January 21, 2021

TO: Planning Commission Members
FROM: Jillian Dierks, Planner, Department of Building and Planning
SUBJECT: TENTATIVE SKETCH PLAN – 355 W. Lancaster Avenue, Haverford, Ward 4, LD# 3880

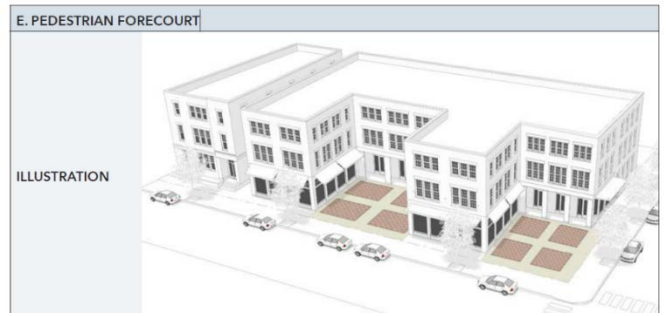
Forecourt: Both Planning Staff and the MCPC have provided the applicant with recommendations on the building frontage and streetscape. Planning Staff recommended that the applicant consider increasing the distance between the curb line and the front façade of the building to provide a forecourt for gathering or outdoor dining. In response the applicant revised the plan to increase the space along the front of the building an additional 2-2.5 feet, increasing the greatest depth to 21 feet, which staff feels is inadequate.

The plan currently includes a large 14,230 sq. ft. outdoor residential amenity space to the rear of the street facing retail. Shifting the retail and first floor space back toward the rear of the site would require internal building layout changes but not a reduction of building footprint. Staff has included a condition requiring the applicant to investigate providing a forecourt along the frontage.
